## Planning Commission Study Session

**SUBJECT:** DR22-168: HILTON GARDEN INN

**GILBERT HILTON GARDEN INN**  
1707 N. HIGLEY RD, GILBERT, AZ 85234  
MANCHESTER UNITED GROUP LLC  
DESIGN REVIEW - 10/06/2022

**BUILDING ELEVATIONS - COLOR**

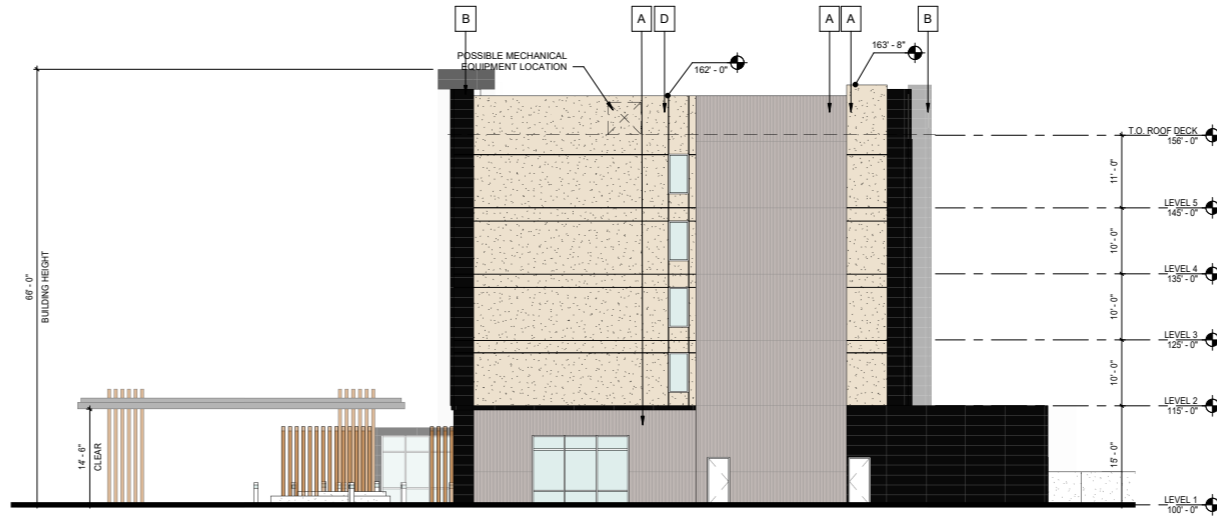
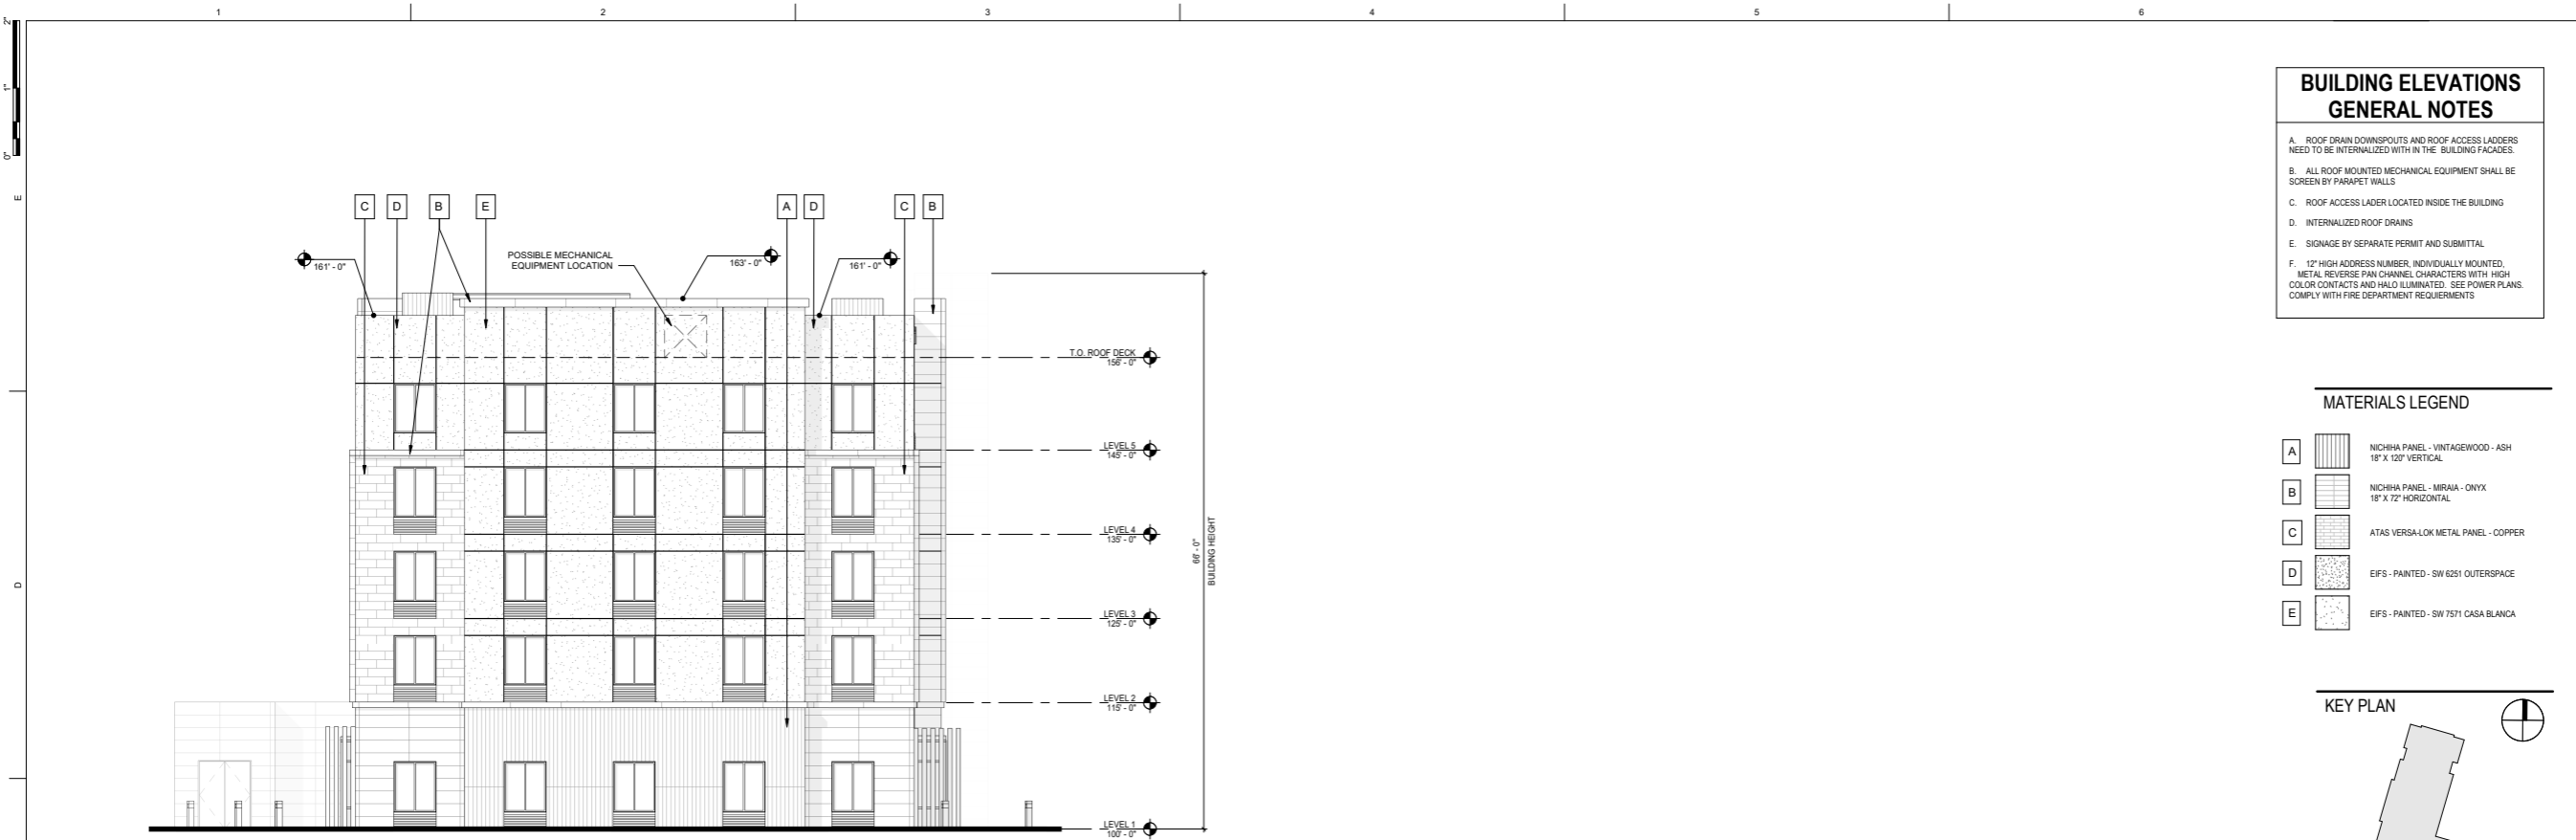
- Staff has expressed concerns about the level of integration between the main structure and the accent masses on the sides of the building. As highlighted in Figure A, the accent masses are extruded out from the side of the building, but when reaching the parapet and building roofline, the masses do not extend any further back into the building, revealing the appearance or what

has been colloquially known as “stick-on architecture,” where building elements do not blend with the larger structure. Staff has asked for input about whether the rooflines of these masses can be adjusted to provide greater integration with the building. Staff also seeks additional input about the design of accent masses, both in material choice and the level of variation and relief used on each mass.

- The parapets of the structure are thinner than what is required by the LDC and commercial design guidelines. However, Town staff seeks input on the overall roofline design and whether any of the following are to be requested to be added to provide greater design quality:
  - o Greater vertical relief between sections of the building, given the building has up to 90’ of height allowed
  - o The addition of roof cornices or other features to avoid the “flat box effect” created on unarticulated rooflines
  - o Increased depth of parapets, or the redesign of the roof area to ensure that changes in height on elevations appear as though the entire building is moving in height, rather than just an exterior treatment (see Figure B).
